**LEVITON**®

*i* **48e and** *i* **96e Dimmer Rack**
**Installation and Maintenance Manual Supplement**

Enclosed is a copy of the Installation and Maintenance Manual for the original product. This supplement serves as a temporary modifier of that manual for the i Series e product. Please follow the instructions in the manual except where modified below.

Luma-Net Termination

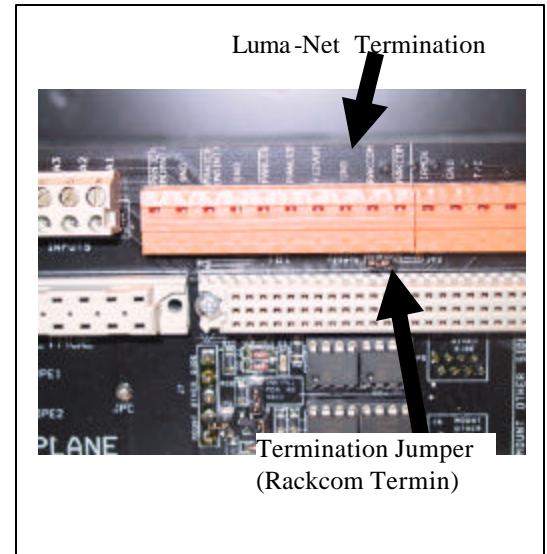
The Luma-Net link connects to the backplane of the rack on TB1 as follows:

Although most Luma-Net phoenix style connectors have six terminals, there is no terminal 5 nor terminal 6 connection at the dimmer rack. Terminal 6 which is used for the hardware lock feature has no use at the dimmer rack and the "terminate" feature which is handled by terminal 5 is handled by the termination jumper.

If the rack is at the end of the run, Jumper JP2 (Rackcom Termin.) must be installed in the backplane to terminate the run. The jumper is shipped installed by factory default.

Breaker with Fluorescent Breaker Handle Tie Kit Installed

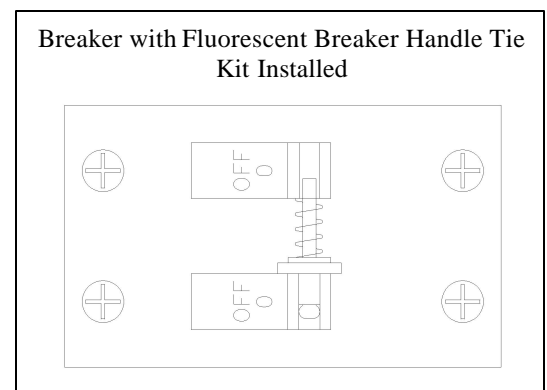
The HILUME feature is only usable in i Series e. This style of fluorescent dimming ballast requires (3) wires, (1) switched, (1) dimmed, and (1) neutral. To accommodate these requirements, the software will couple the odd-numbered dimmer with the next even-numbered dimmer. The odd-numbered dimmer is the variable component and the even-numbered dimmer is the switched component. The breakers for these dimmers must be tied together with the CTP-4-0307 fluorescent handle-tie kit and the rack slot labeled. Installation instructions for this are included with the kit.
